***MAJOR PROJECT ASSESSMENT:
Oakdale Central Concept Plan and
DHL Logistics Hub Project,
Horsley Park***

Director-General's
Environmental Assessment Report
Section 75I of the
Environmental Planning and Assessment Act 1979

October 2008

Figure 6: Conceptual design of upgrades to Old Wallgrove Road

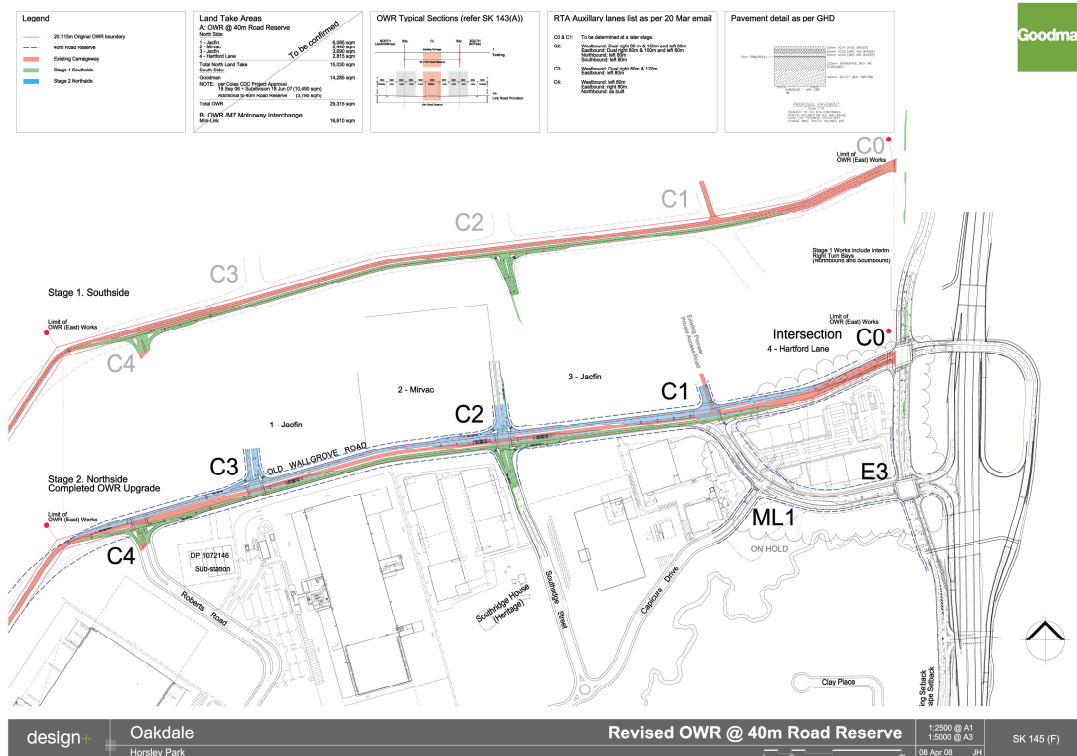
Under previous approvals granted by the Minister for industrial development in the Eastern Creek Precinct (Area 2), Goodman is required to upgrade Old Wallgrove Road between the Old Wallgrove Road/Wallgrove Road intersection and Roberts Road (as shown in Figure 6) by providing an additional two lanes.

Although Goodman has been asking Blacktown Council to approve this upgrade under the *Roads Act* for some time now, until recently Council has indicated that it would not approve the upgrade while the strategic planning framework for the area, and in particular the development of the Link Road, remains unresolved.

The Department agrees with this conclusion, particularly because Old Wallgrove Road currently only services a small portion of the WSEH, primarily due to the delay in developing the Link Road. It also believes that this is likely to remain the case for at least the next three to five years while both the Link Road and Chandos Parkway are being developed.

Figure 9: Vegetation Offset Areas

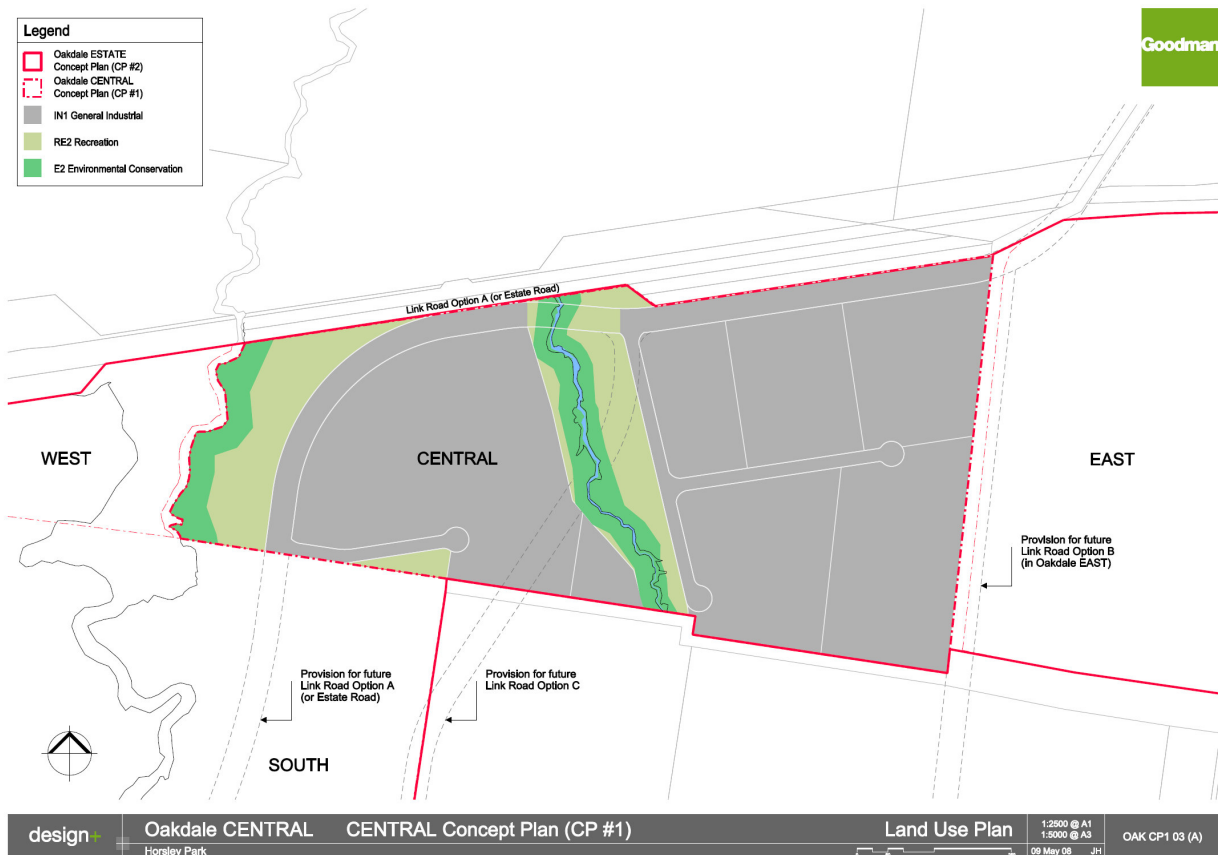
Development of the Oakdale Central would require the removal of ~1.35ha of native vegetation including Swamp Oak Floodplain Forest (0.19ha), degraded woodland (0.35ha) and wetland vegetation (0.81). To compensate for the clearing of this vegetation, Goodman proposes to revegetate an area of 4.27ha (see Figure 9). In relation to riparian vegetation, significant enhancement works would be undertaken along Ropes Creek and its tributaries. Lesser streams, known as Category 3 under the DWE classification, would be removed as part of the project.

The removal of vegetation on the site is not considered significant due to the small quantity and generally poor quality of the vegetation. Overall, there would be a net increase in vegetation on site through the implementation of the proposed offset strategy which would ultimately improve the quality of vegetation on site. By improving the riparian vegetation along the Ropes Creek corridor, connectivity along Ropes Creek would be provided, in particular to the north beyond the site boundary. A Vegetation Management Plan (VMP) would be developed and implemented for the project incorporating the proposed offset strategy.
